REPORT ON PROPOSALS

THE WATER EFFICIENCY AND SANITATION STANDARD
TECHNICAL COMMITTEE REPORT ON PROPOSALS FOR
PUBLIC REVIEW AND COMMENT

Enclosed is your 2022 Report on Proposals (ROP).

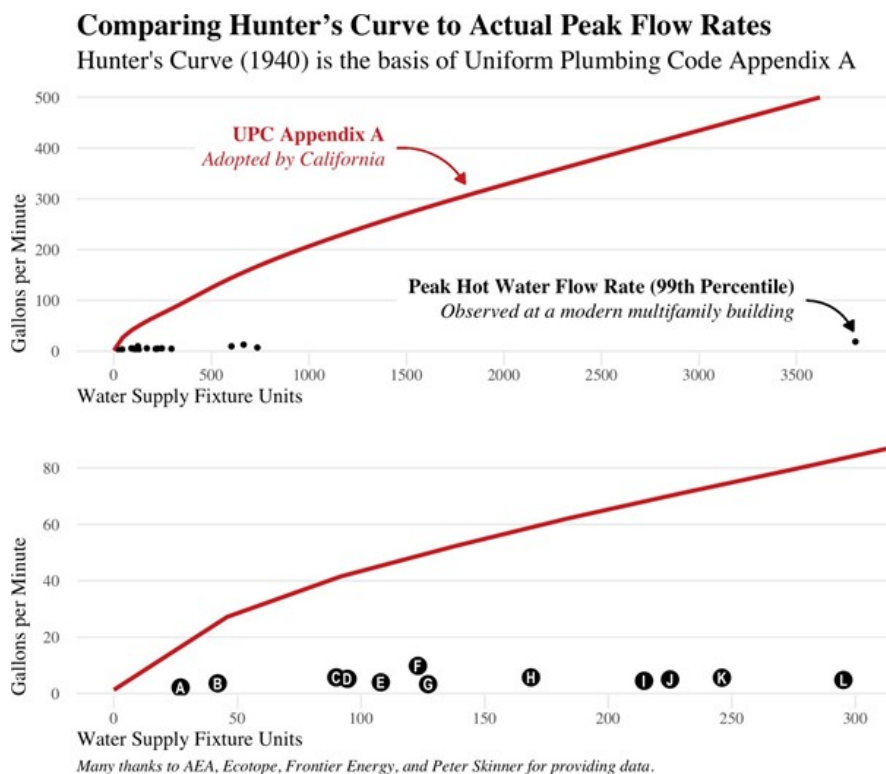
Figure 1 from the Petition provides a comparison of Actual Peak Flow Rates to calculated rates using the Hunter’s Curve. The figure underscores that the standard practice – based on the Hunter’s curve – overestimates the peak flow rates when compared to use with plumbing fixtures and appliances that have been in buildings since the Energy Policy Act of 1992 went into effect the mid-1990s.

Comparing Design Predictions to Actual Peak Flow Rates

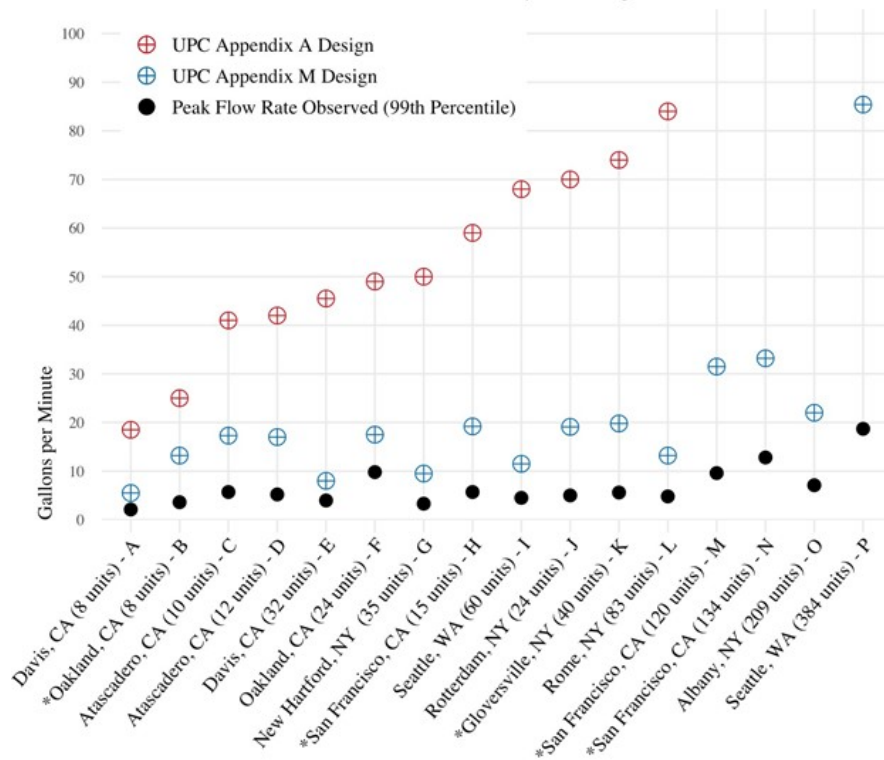
Figure 2 from the Petition compares the monitored data from the 16 multifamily buildings to the peak water demand estimates based on UPC Appendix M. The comparison shows that Water Demand Calculator provides a conservative approach to estimate peak water flow rates, providing a margin of safety at least 1.8 times the measured data in multifamily buildings.

Figure 1 - Silicon Check Valve (New)

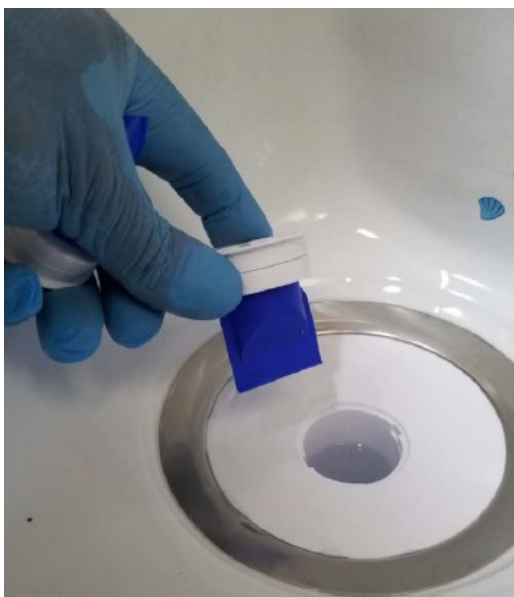
The proposed language allows a greater selection of backflow traps to be used. Waterless urinals have seen great success in silicon mechanical backflow seals. (See Figure 1 and Figure 2 below.) However, under the current plumbing code, a mechanical backflow device or check valve can not be used without a liquid "P-trap" or sump.

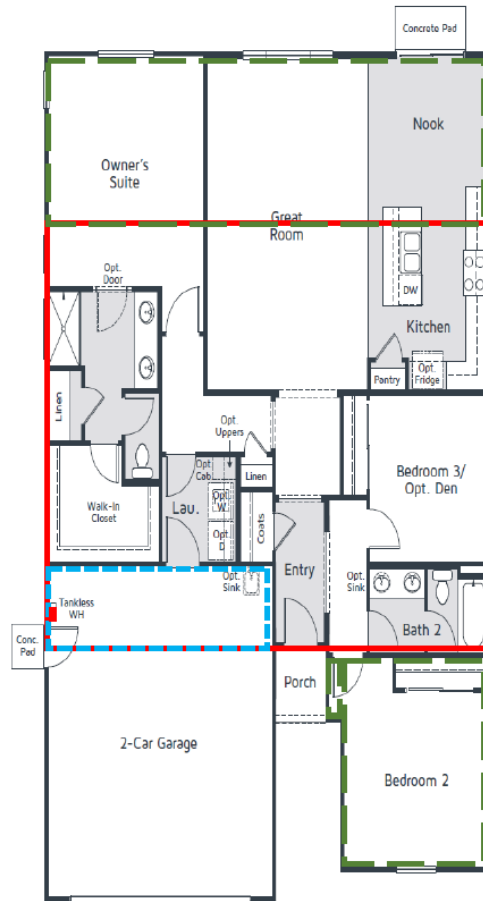
This "maximum hot water system ratio" is intended to promote efficient floor plan layouts to limit heating energy and water-use. Inefficient fixture locations will have long hot water wait times, resulting in greater water use and heating energy with no benefit to the user. The values of 60% and 30% here are achievable in common fixture arrangements in most dwellings, while prohibiting the most inefficient layouts.

In the below example, the red rectangle is drawn to match the boundary of where all fixtures are located. The green rectangles represent the portions of the dwelling where there are no fixtures located. When accounting for the red area with respect to the total of the green and red areas, it can be seen that 67% of this dwelling is covered by the red area, meaning plumbing fixtures are spread throughout 67% of the dwelling.

**FIGURE 3-C 102.1(3)
CHART A 405.4(4)-C 101.1(1) FOR FINDING PIPE SIZE**

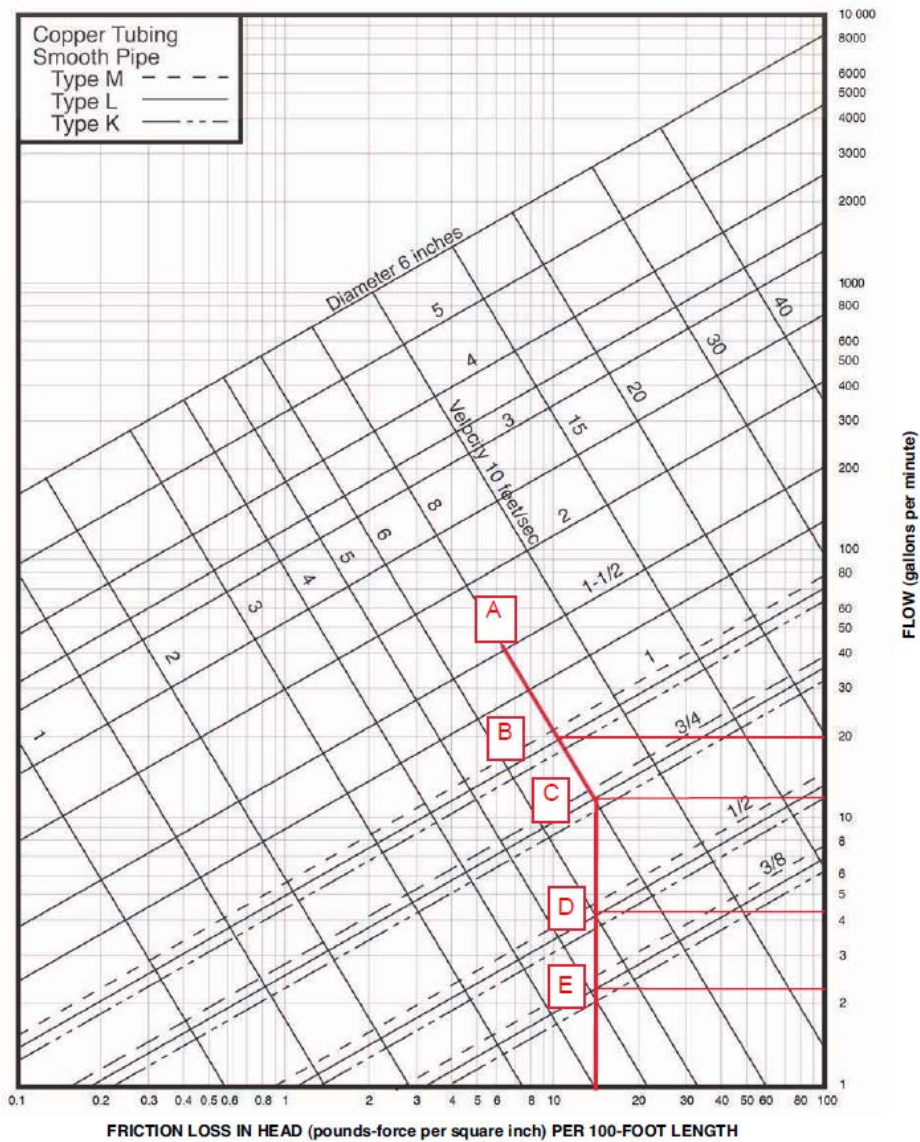
Chart A 105.1(1) for copper piping systems (from Appendix A of the UPC, shown in Figure 3) Figure C 102.1(3) is used to determine the pipe size, based on given friction loss, given maximum allowable pipe velocity, given pipe material and the demand load computed in Step 1. In Figure 3-C 102.1(3), the intersection of the given friction loss (15 psi) (103 kPa) and the maximum allowable pipe velocity (108 ft/s) (2.4 m/s) is labeled point A. The vertical line that descends from point A to the base of the chart, intersects four nominal sizes for L-copper pipe. These intersection points are labeled B, C, D, E and correspond to pipe sizes of 1 inch (25 mm), ¾ inch (20 mm), ½ inch (15 mm) and 3/8 inch (10 mm), respectively. A horizontal line from points B, C, D, E to the right-hand side of the chart gives maximum flow rates of 2420 gpm (1.3 L/s), 12 gpm (0.75 L/s), 4.5 gpm (0.28 L/s), and 2.3 gpm (0.15 L/s), respectively. These results are

CHART C 101.1(1)

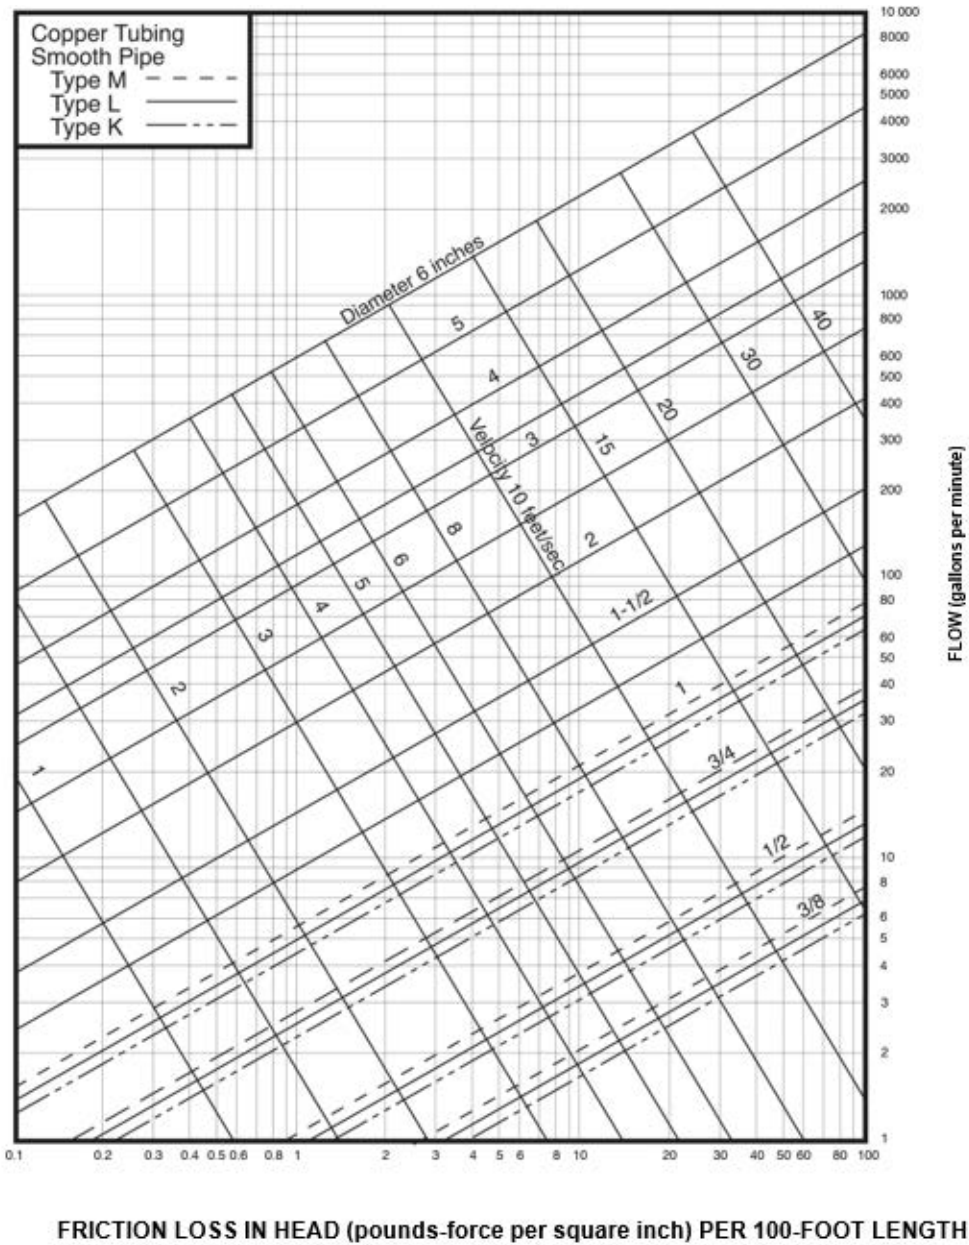
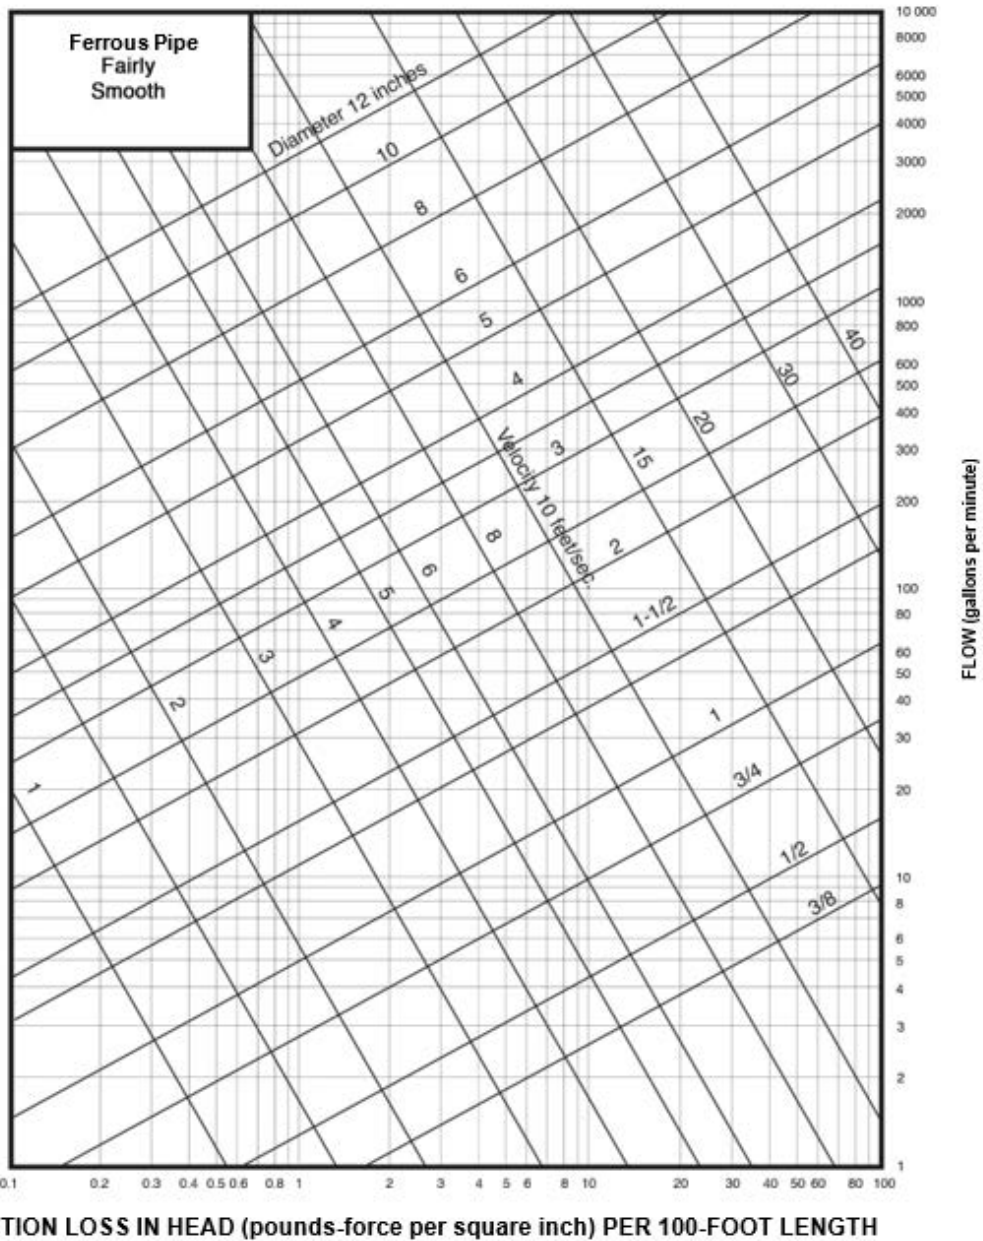
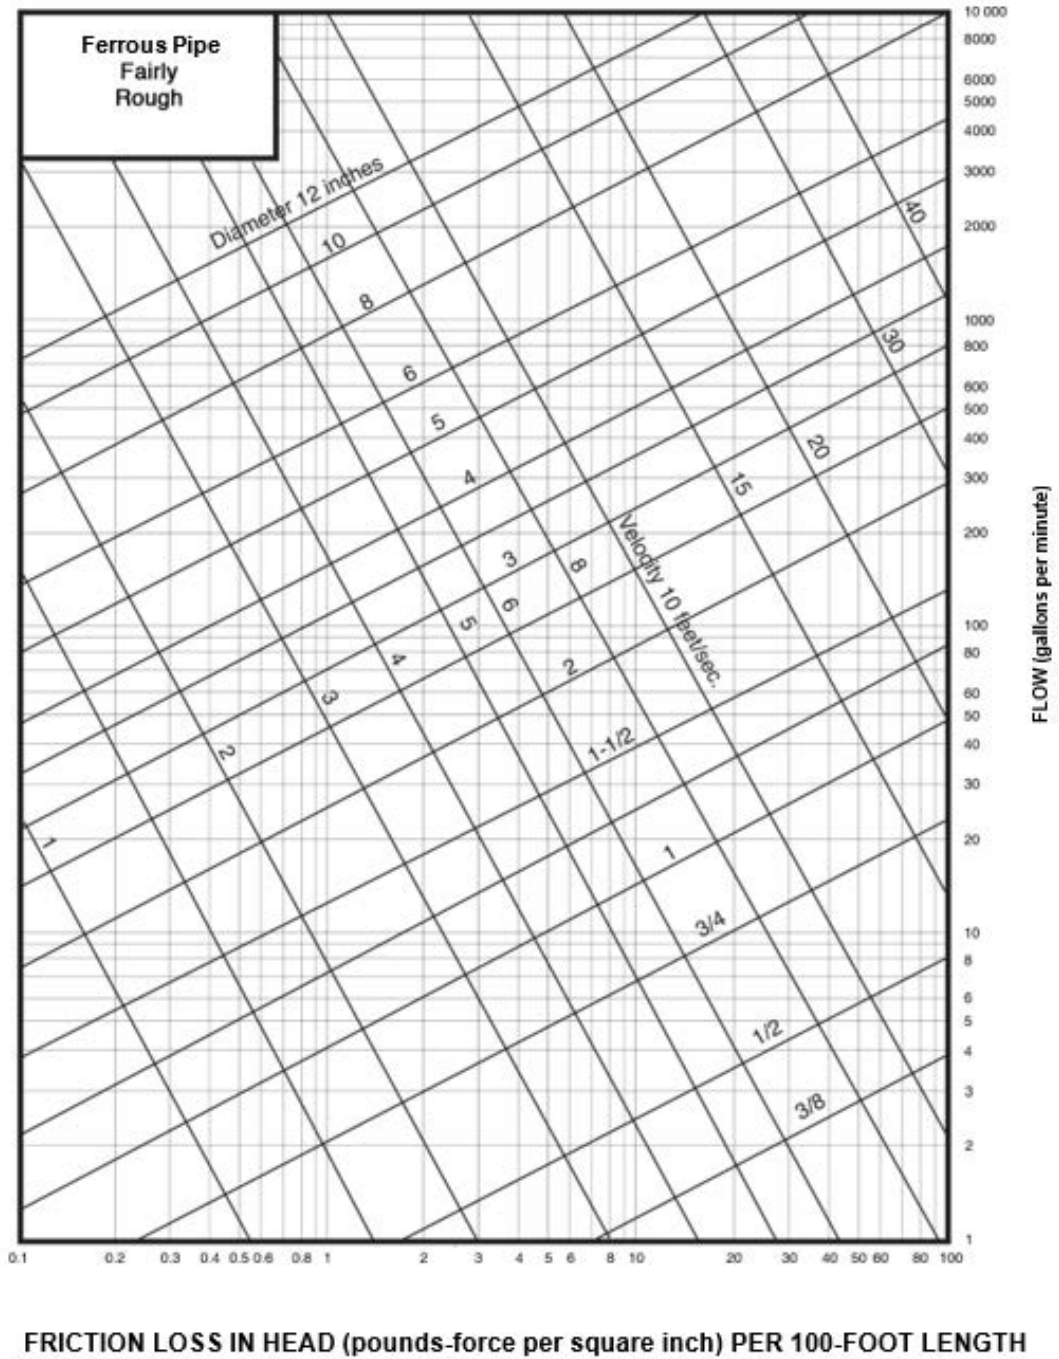
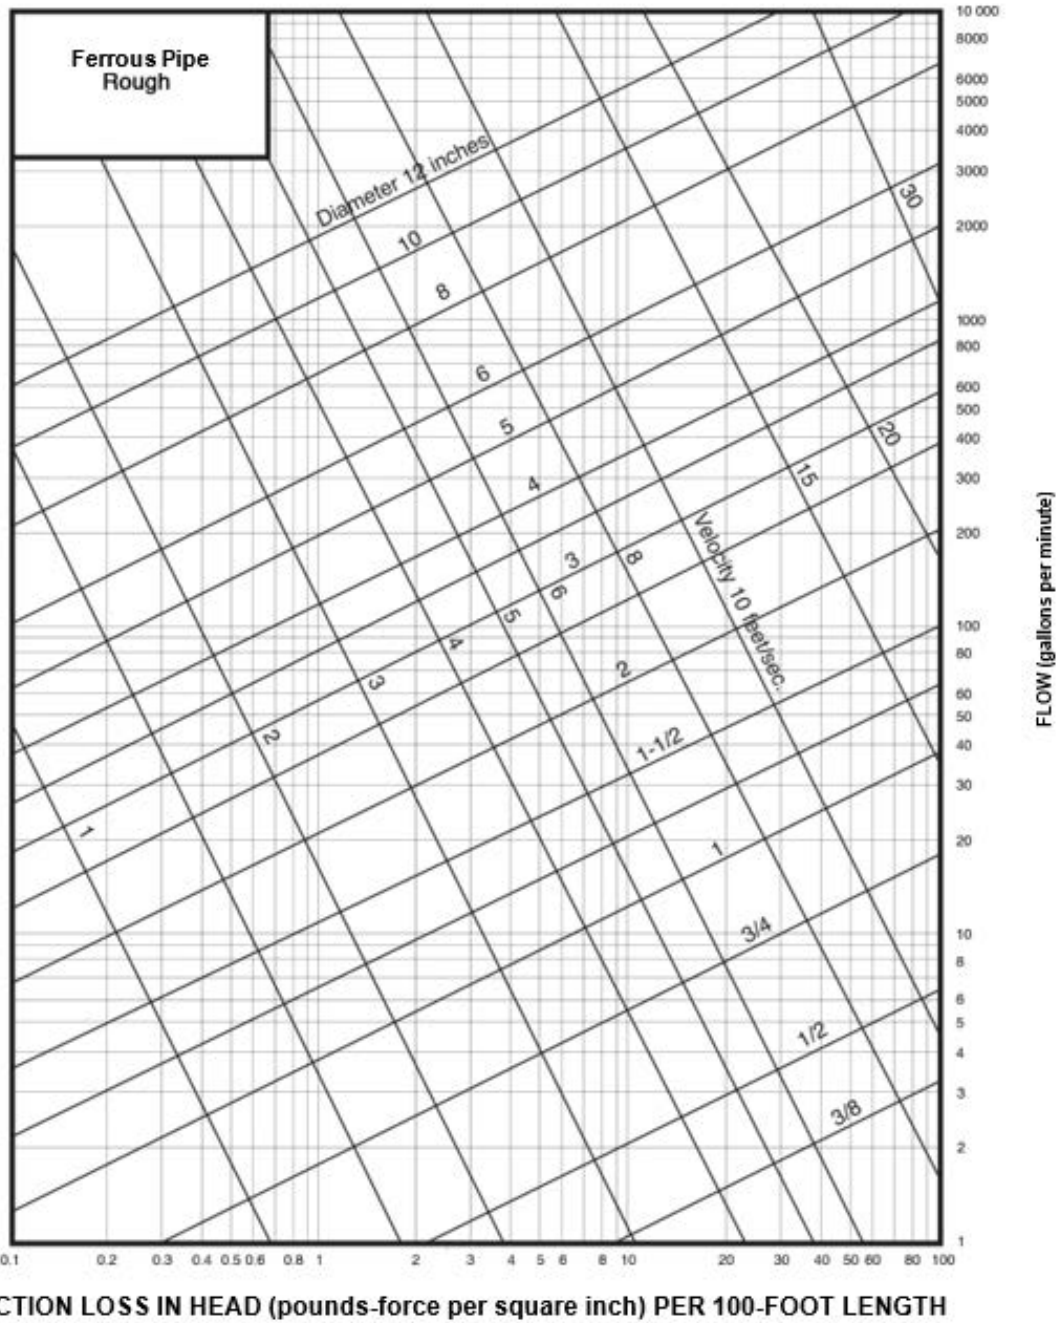
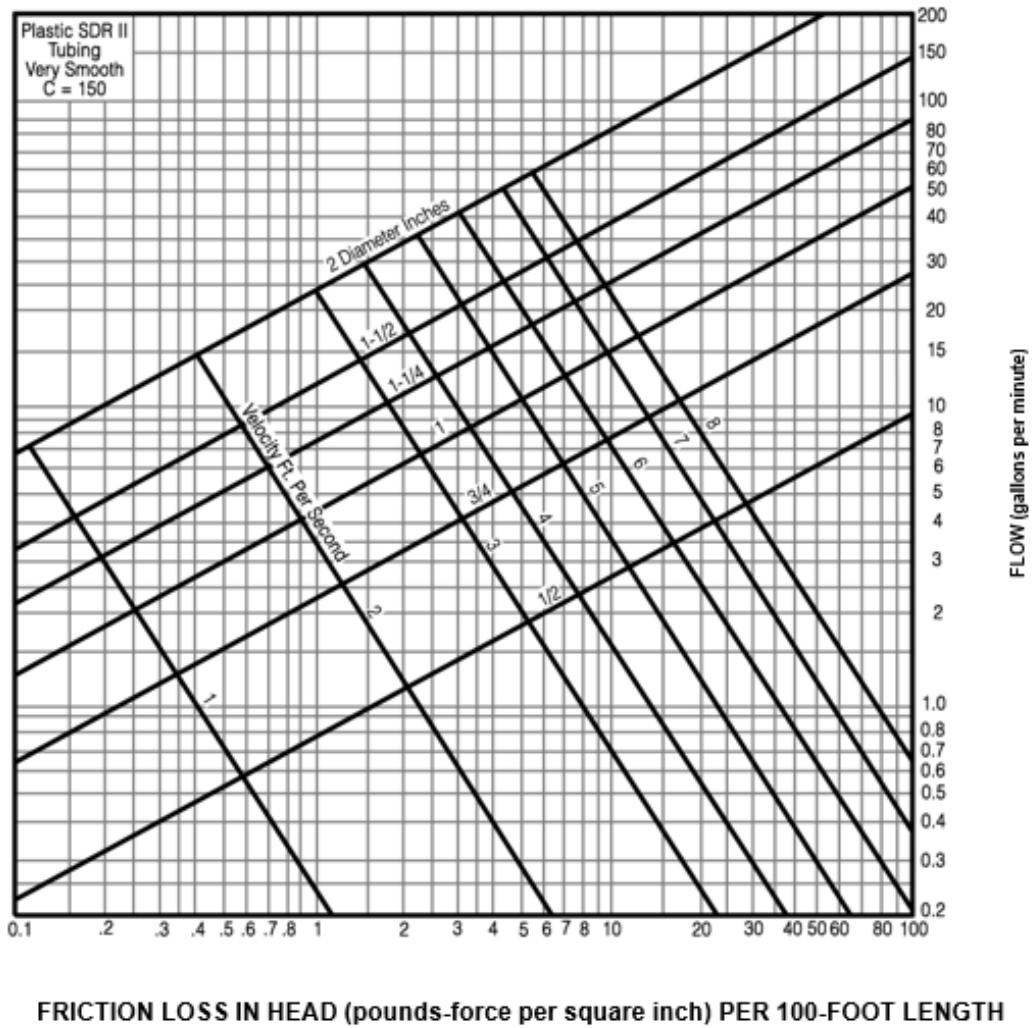
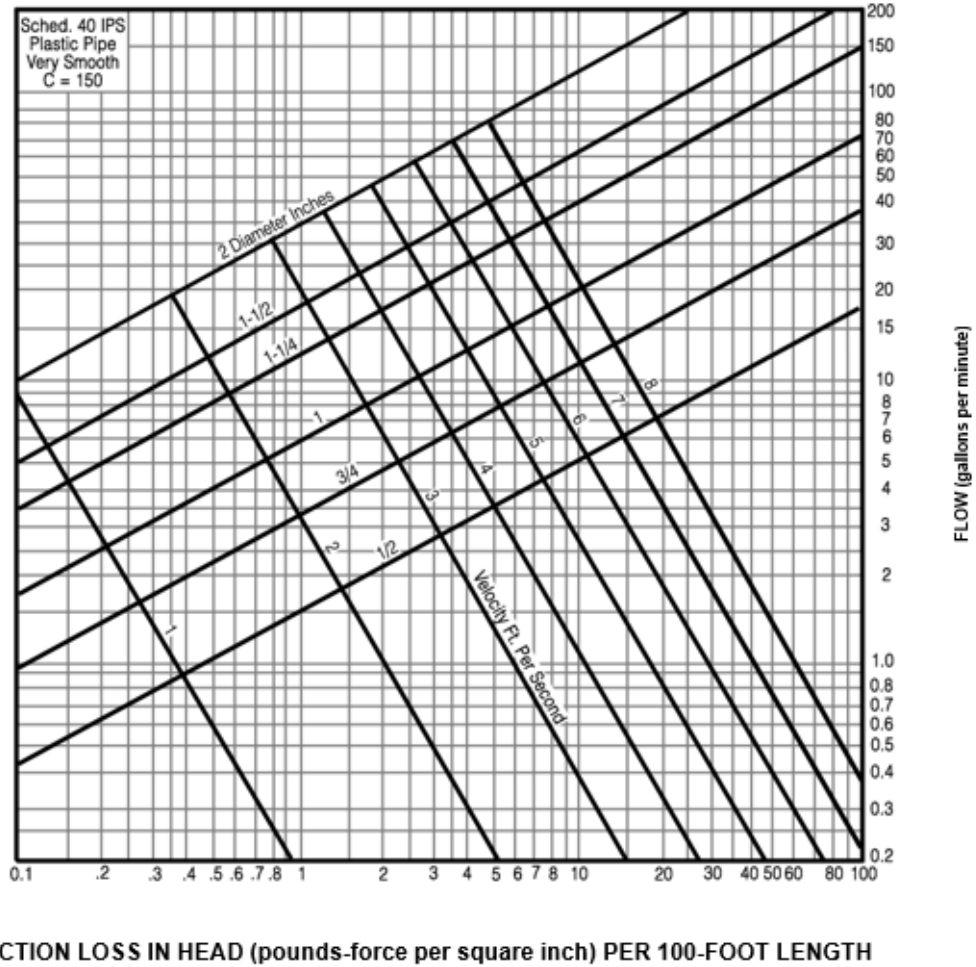
Based on the actions taken on Item #074, Item #123 is also being rejected. Chart C101.1(1) through Chart C101.1(9) from this proposal should be relocated to Chapter 5. This relocation would prevent conflict where Appendix C is not adopted by the jurisdiction and ensure applicable tools are provided for utilizing the WDC. The Technical Committee has identified this as the only reason for rejection and requests this change be made via public comment.
